PRODUCT / PROCESS CHANGE NOTIFICATION

1.1 Company	 STMicroelectronics International N.V
1.2 PCN No.	MDG/24/14537
1.3 Title of PCN	ST CALAMBA(Philippines) additional assembly plant for STM32MP13x products in TFBGA 9X9, TFBGA 11X11 and LFBGA 14X14 packages - on listed products.
1.4 Product Category	STM32MP13x products in TFBGA 9X9, TFBGA 11X11 and LFBGA 14X14 packages
1.5 Issue date	2024-06-26

**PRODUCT/PROCESS
CHANGE NOTIFICATION
PCN14537
– Additional information**

**ST CALAMBA(Philippines) additional source for STM32MP13x
products in TFBGA 9X9, TFBGA 11X11 and LFBGA 14X14
packages - on listed products.**

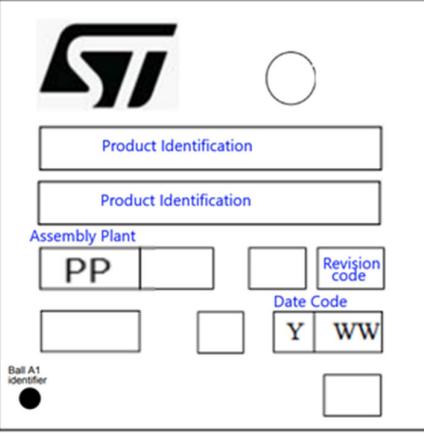
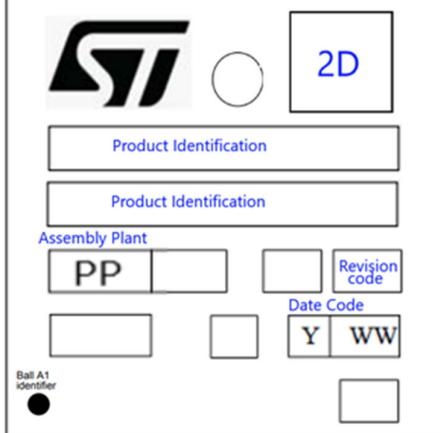
ST General Purpose Microcontrollers Division decided to qualify an additional back-end assembly site. The full process transfer to ST CALAMBA Assembly site is done maintaining state of the art service level to our customers thanks to extra capacity. This PCN is limited to STM32MP13x listed products in TFBGA 9X9, TFBGA 11X11 and LFBGA 14X14 packages.

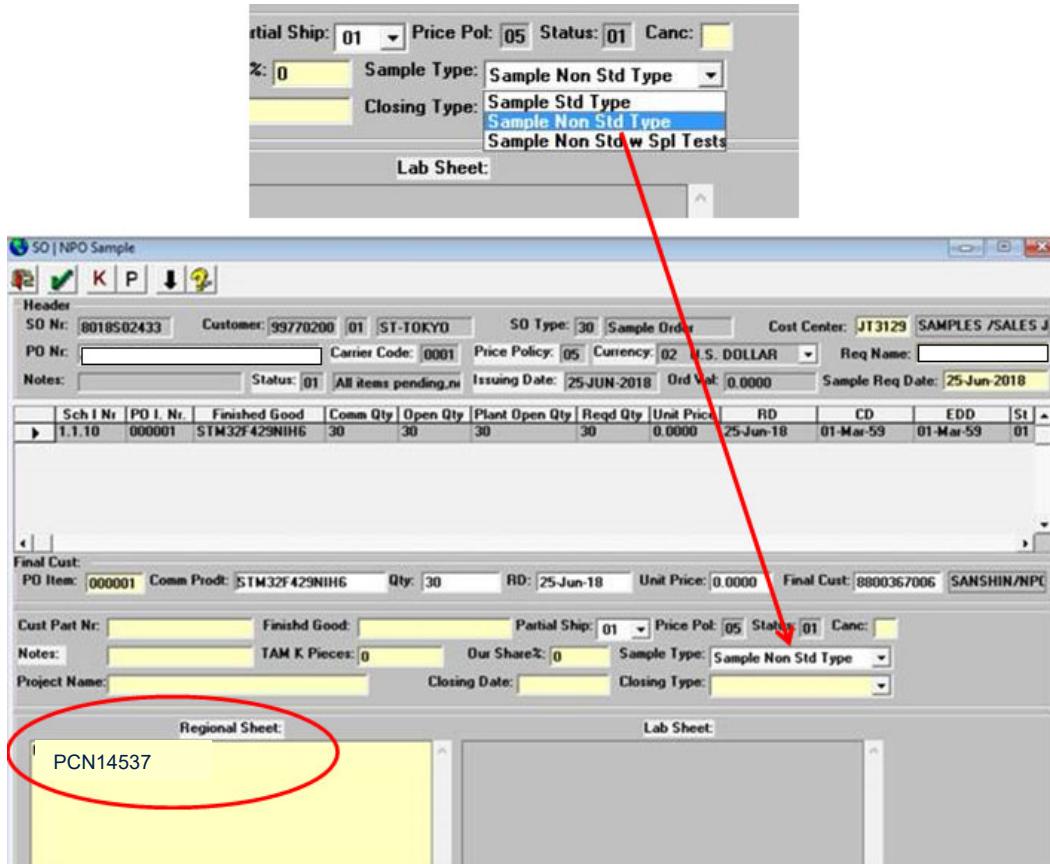
Marking	Existing	Added Back-End Site
Assembly site	ASE KaoHsiung (Taiwan)	ST Calamba (Philippines)
TFBGA 9X9, TFBGA 11X11 and LFBGA 14X14		
PP code	AA	78

Y WW code indicates Year Week (manufacturing date)

PP code indicates assembly traceability plant code:

- **AA** for ASE KaoHsiung (Philippines)
- **78** for ST CALAMBA (Philippines)
